A. DESCRIPTION OF THE PROPOSED CHANGE

This proposed amendment will revise Technical Specification Figures 3.1-3 and 3.1-4. These figures provide regulating group Control Element Assembly (CEA) insertion limits. Figure 3.1-3 provides CEA insertion limits when the Core Operating Limit Supervisory System (COLSS) is in service and Figure 3.1-4 provides the insertion limits when COLSS is out of service. The following two changes are proposed:

This proposed amendment will revise Technical Specification Figure 3.2-1A. This figure provides azimuthal power tilt limits versus core power for COLSS in service. The azimuthal power tilt limit will be increased for operation below 40% of rated thermal power.

This proposed amendment will revise Technical Specification Figures 3.2-2 and 3.2-2A. These figures provide DNBR margin limits for various configurations of COLSS and CEACs inoperable. The changes are necessary to ensure that the Technical Specifications are consistent with the safety analyses performed for the Cycle 3 core design.

FIGURE 3.2-2A

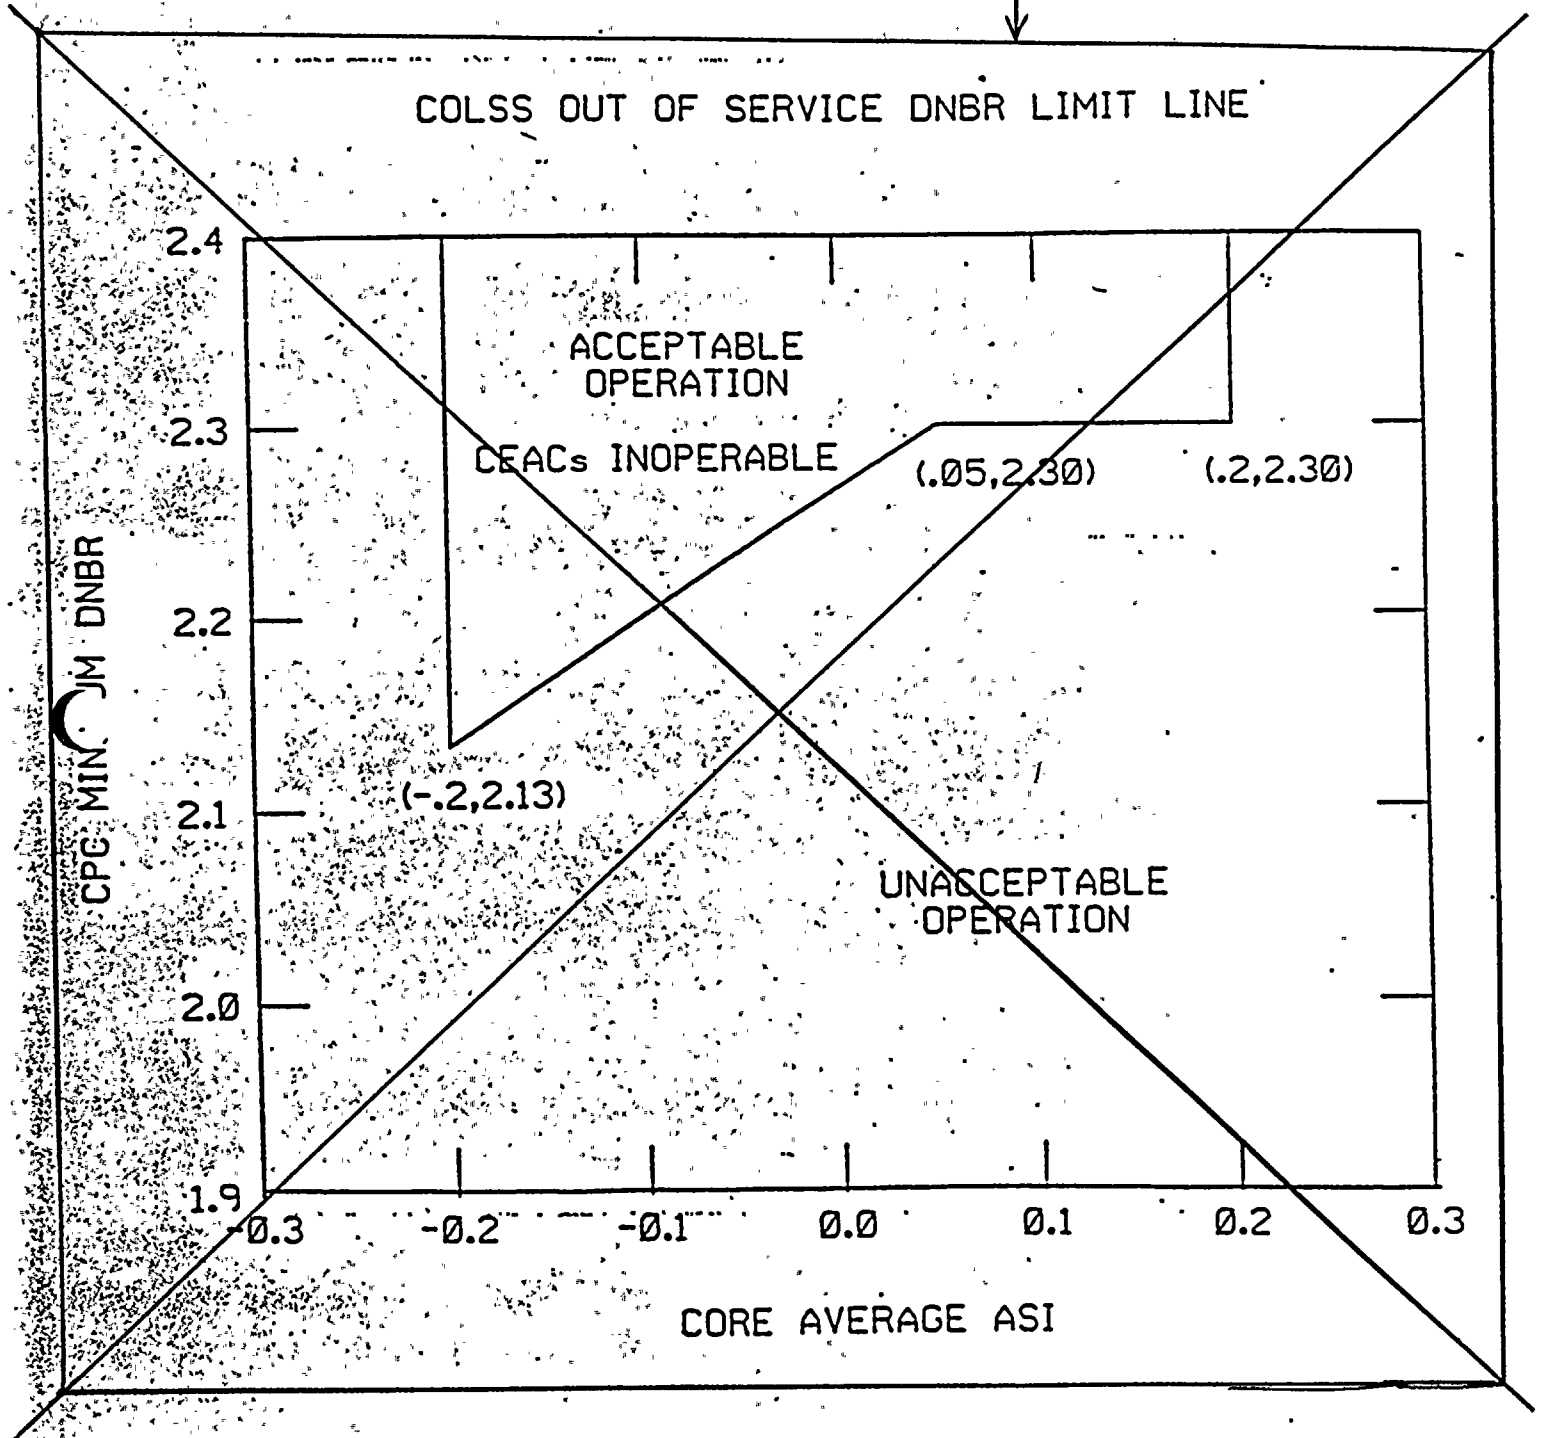
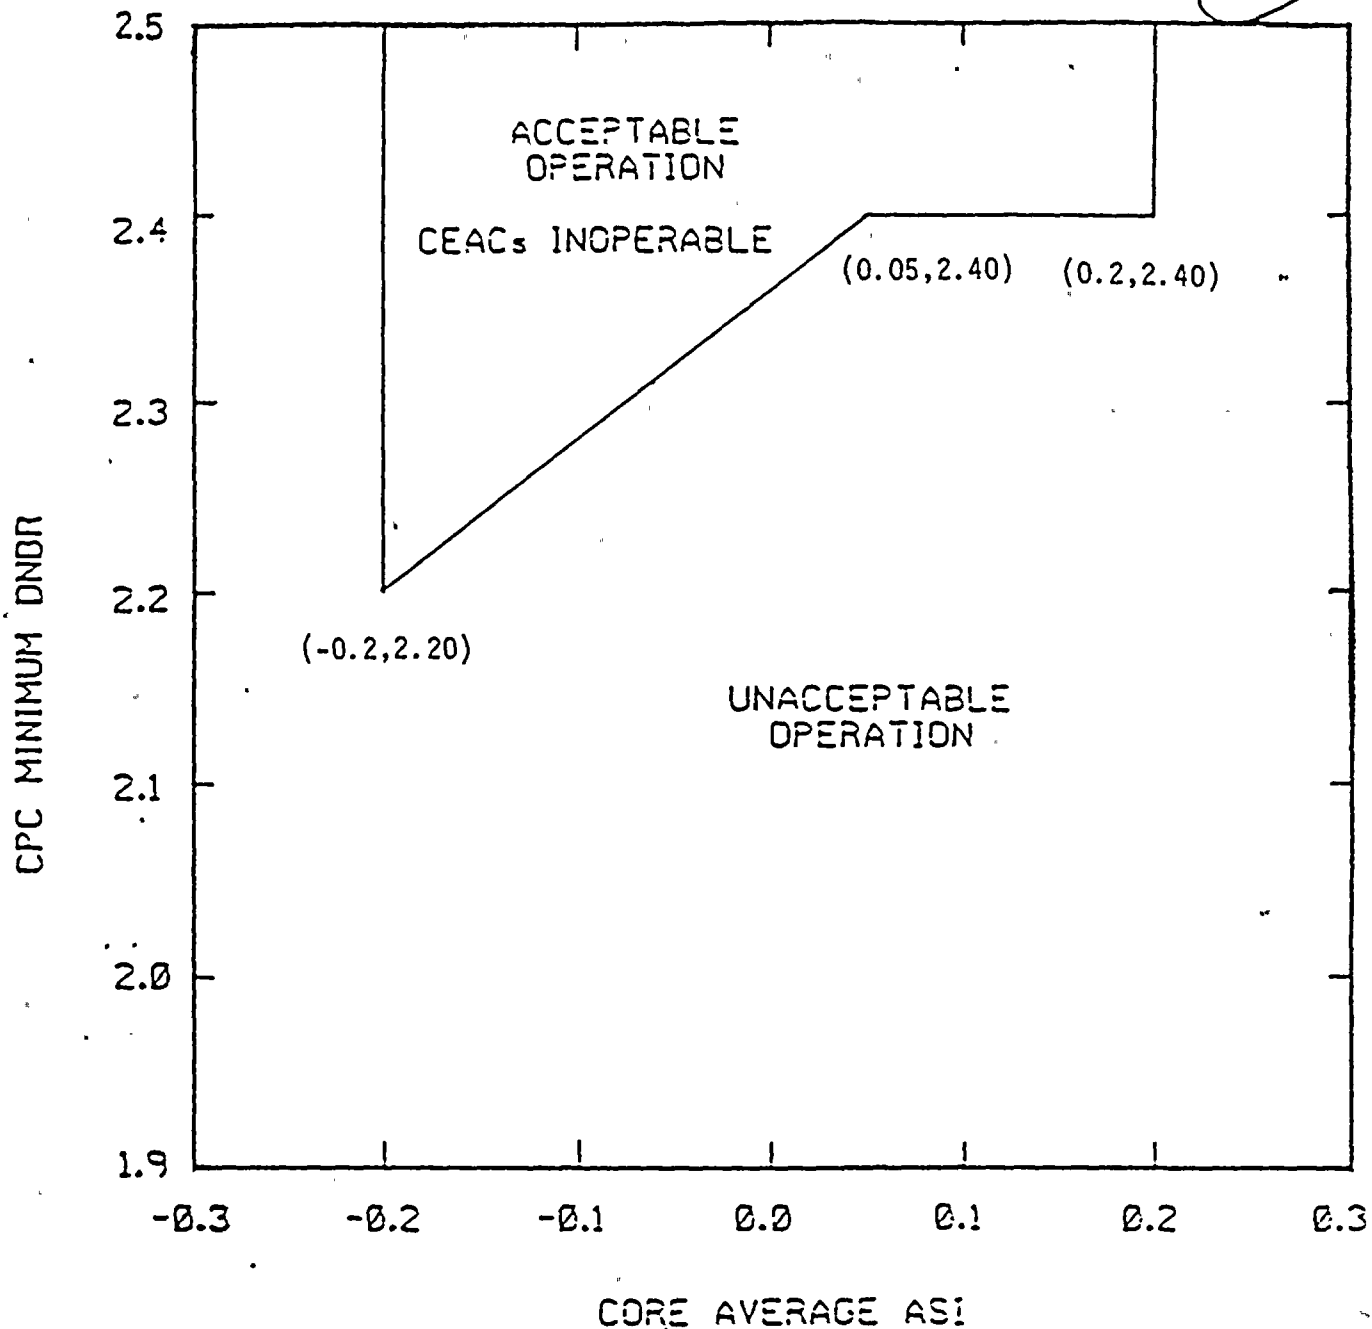
REPLACE WITH
NEW FIGURE 3.2-2A

- c. When COLSS and both CEACs are out of service, there must be additional margin in the initial CPC DNBR value to ensure that the limiting AOO will not result in exceeding a SAFDL. The evaluation of the Cycle 3 core design has shown that by maintaining the CPC calculated DNBR above the limits shown in Figure 3.2-2A, the SAFDLs will not be exceeded during the most limiting AOO.
